## Certificate of Appropriateness

1909 N. 2ND ST.      Brewers Hill

PTS ID 114868 COA: masonry, roof, and windows

Approved window designs

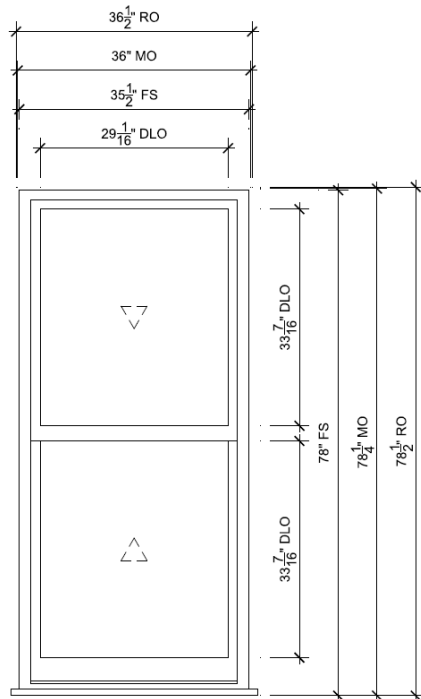
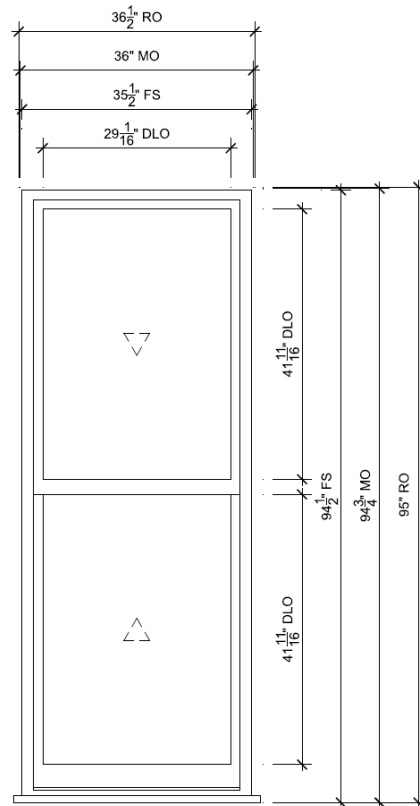
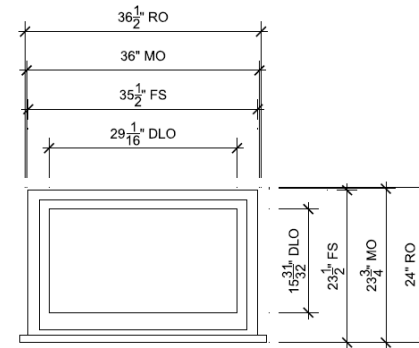
One window and its transom on the north side will be replaced with a new wood-exterior Marvin Ultimate Double Hung. The transom may be repaired with new glass and epoxy products rather than replaced.

Replacement windows will be all wood both inside and out. No vinyl, vinyl-clad, aluminum, aluminum-clad or fiberglass windows are permitted. New glass size must match the original glass size. Muntin profiles and sash heights must match originals.

North Wall

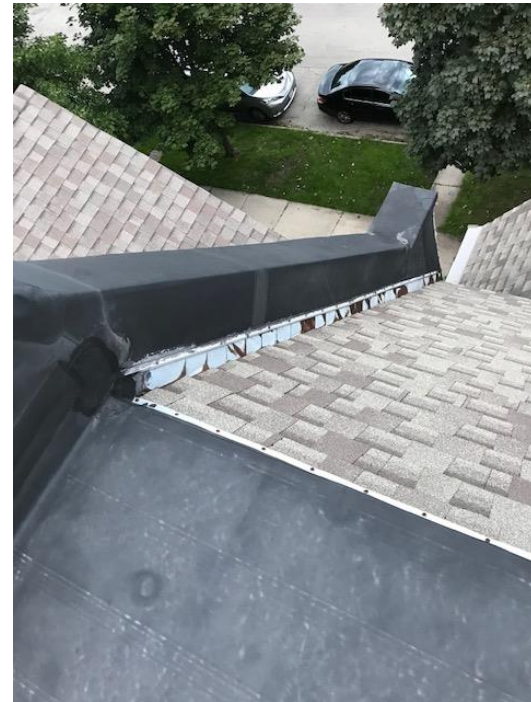
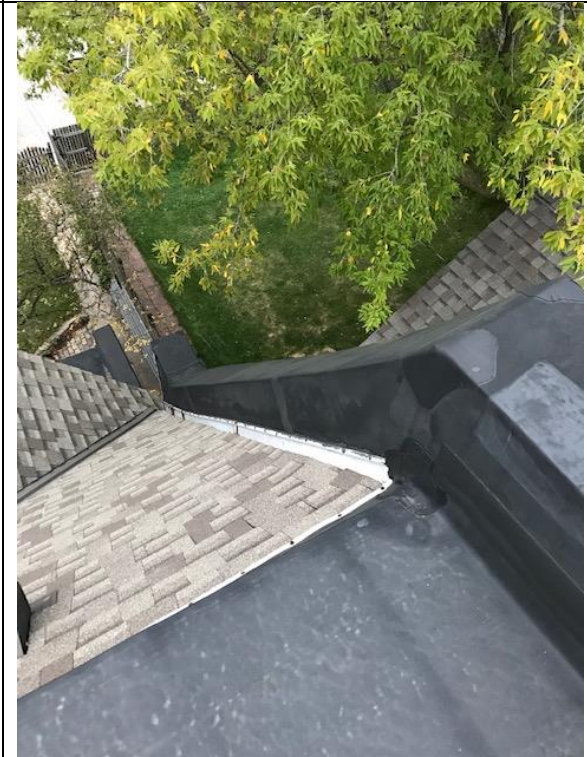
The north wall of the home will be secured via the removal of loose bricks. The removed bricks will be cleaned up and stored for reuse, but some reclaimed bricks will be mixed in throughout to compensate for loss of broken brick. Similarly, the west wall of the home will be repaired. Scaffolding will run up the west side of the home to the parapet. Loose bricks will be removed. Tyvek building wrap will cover the wall, and new commercial wall ties will be installed for the brick, 16" on center. The mixture of new and existing brick will be laid with Portland and lime mortar. Mortar joints will match the existing conditions. Angle iron will be laid over the windows and flashing with weep vents every 3rd brick will be placed across the head joint.

Roof repairs: A new wood nailer will be installed at the top of the brick walls. A new EPDM rubber flashing will run up the inside of the wall, over the wood nailer, and down the brick wall for a few inches. The new flashing will be adhered to the existing rubber membrane and, if necessary, to the shingles on the sloped roof. The flashing around the chimney will be redone as necessary. New prefinished metal coping will be fabricated and installed to the wood nailer. The coping will be a mansard brown to match the existing conditions.

New mortar must match the original mortar in terms of color, texture, grain size, joint width, and joint finish/profile (*with Cream City Brick, this means Type O or softer mortar*). The compressive strength of the repointing mortar shall be equal or less than the compressive strength of the original mortar and surrounding brick or stone. The replacement mortar shall contain approximately the same ingredient proportions of the original mortar. Mortar that is too hard is subject to premature failure and could damage the masonry. See the city's books *As Good As New* or *Good for Business*, Masonry Chapters, for more information. In most cases, this means a lime mortar with natural hydraulic cement rather than Portland cement. No joint of a width less than 3/8" may be cleaned of damaged/decomposed mortar with power disc grinders. No over-cutting of the joints is permitted. Remove decomposed mortar back into the wall 2.5 times the height of the joint before repointing.

No dormers, chimneys, moldings parapets, or other permanent features will be altered or removed. No box vents, if used, will be visible from the street. If they are installed, they must be on a rear slope not visible from the street and they must be painted to blend with the color of the roofing material. A continuous ridge vent can be installed in place of box vents, but the vent must extend across the entire ridge and not stop short. Built-in rain gutters will be retained and sealed where needed. Valleys must be metal W-shape with no interweaving of shingles. Valleys and flashing must be painted or factory-finished to match the roofing color, unless copper. When installing new flashing at a masonry feature, the flashing must be stepped or cut into the mortar joints. The bricks may not be cut to install flashing at an angle.
